**PLANNED UNIT DEVELOPMENT
& SUBDIVISION STAFF REPORT**

Date: May 17, 2007

DEVELOPMENT NAME Toulminville Subdivision

LOCATION 517 and 518 Dixie Street
(Southeast corner of Dixie Street and Schwarz Street, and extending South to Clement Street & Northeast corner of Dixie Street and Clement Street, and extending North to the corner of Hathcox Street and Schwarz Street)

SITE PLAN

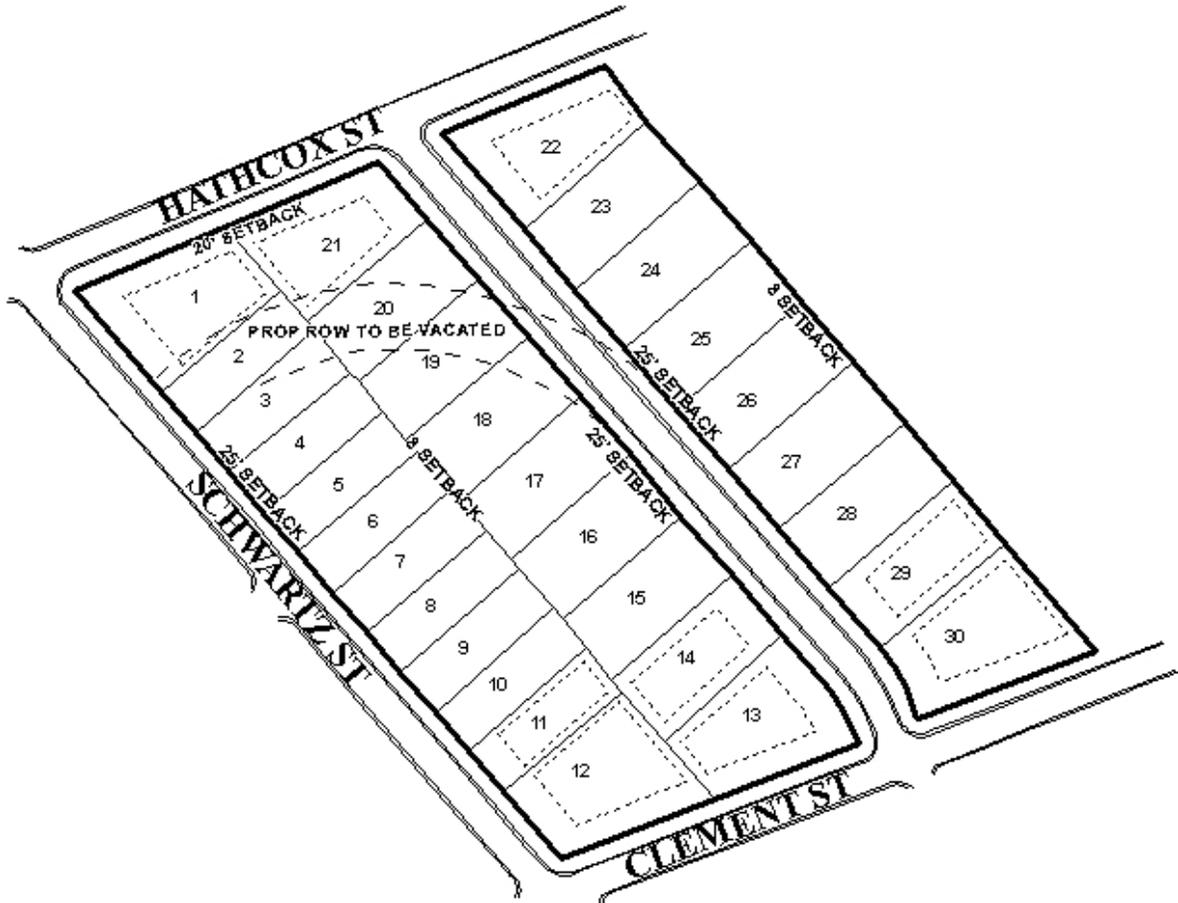
The plat and site plan do not indicate any sort of storm water detention facility. If such a facility is required by the Engineering Department, the plat and site plan should be revised to depict the facilities prior to the recording of the final plat. A revised site plan should also be provided to the Planning Section of Urban Development prior to the signing of the final plat, if approved.

Finally, the PUD site plan should be revised to depict sidewalks along all street frontages. The dedication of additional right-of-way along Hathcox and Clement Streets should provide adequate space for sidewalks, and the proximity of the elementary school and the residential nature of the area underscores the need for sidewalks for the site.

- 6) revision of the plat to show the minimum building (side yard) setback line along Hathcox and Clement Streets as 15 feet instead of 20 feet;
- 7) revision of the plat to show the 25-foot minimum building setback lines along all other street frontages;

- 7) revision of the site plan to show the minimum building (side yard) setback line along Hathcox and Clement Streets as 15 feet instead of 20 feet;
- 8) revision of the site plan to show the 25-foot minimum building setback lines along all other street frontages;
